Android Indoor Station Firmware V2.1.78_build221209 Release Note (2022-12-09)

Device Model	DS-KH9310-WTE1, DS-KH9510-WTE1
Firmware Version	Android Indoor Station : V2.1.78_build221209
iVMS-4200 Version	Latest baseline
Hik-Connect APP	Latest baseline

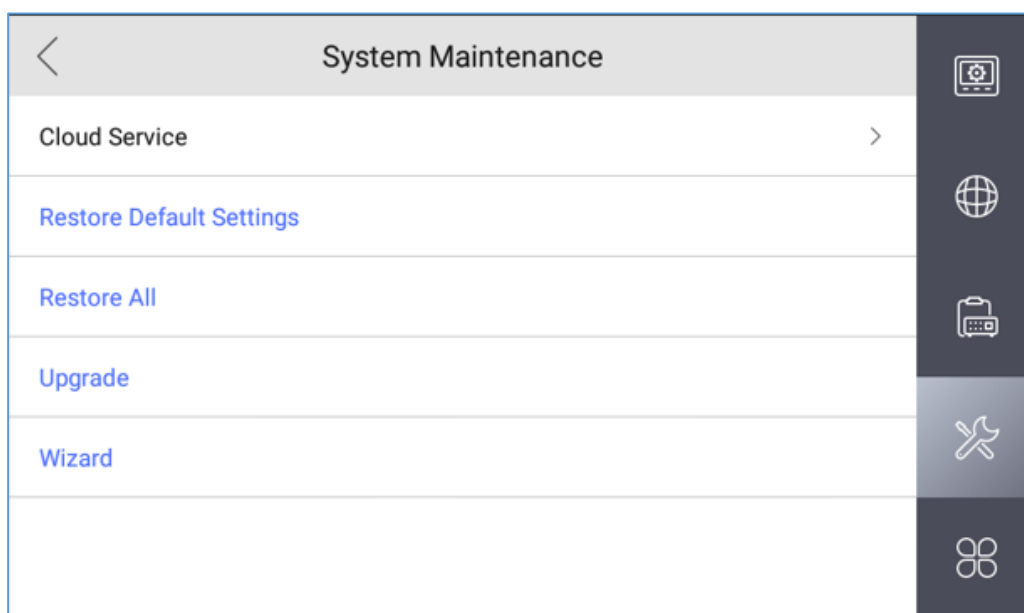
1. Verification code is empty by default.

2. Hik-Connect Service Settings is changed to the place of Settings → Advanced Settings → Configuration → System Maintenance.

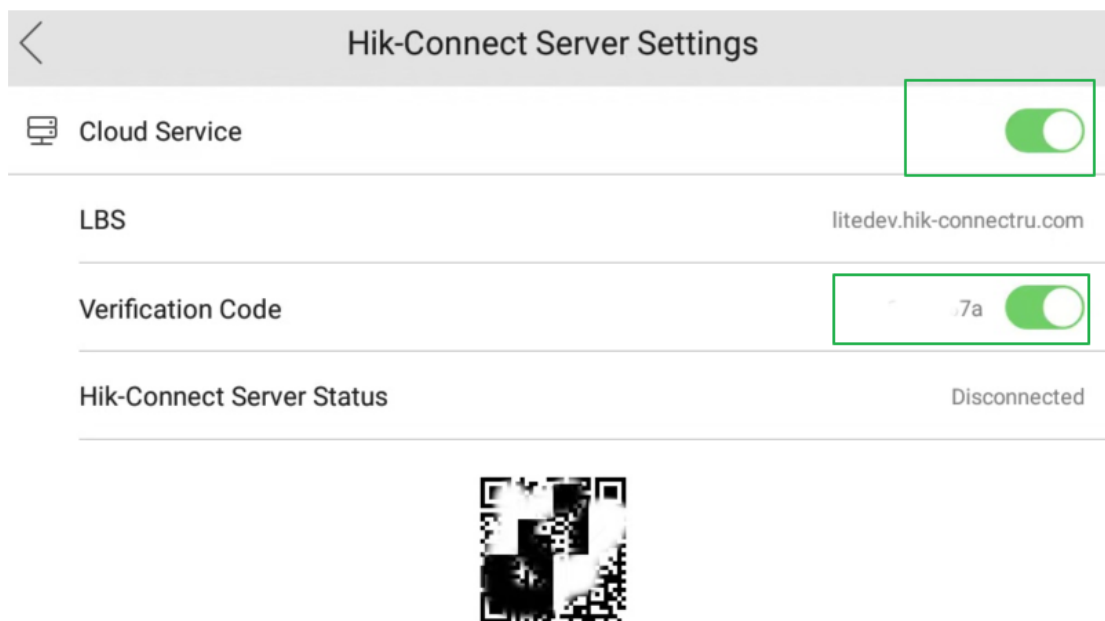
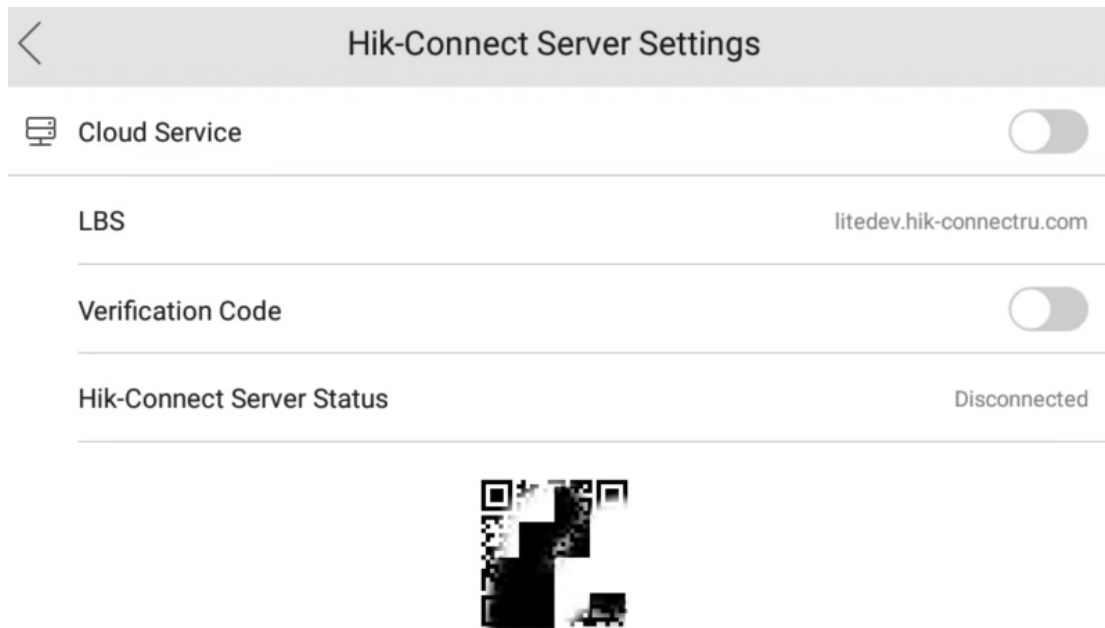
1. Hik-Connect service is disabled by default for privacy protection and add Enable Switch for

verification code display in Hik-Connect Server Settings.
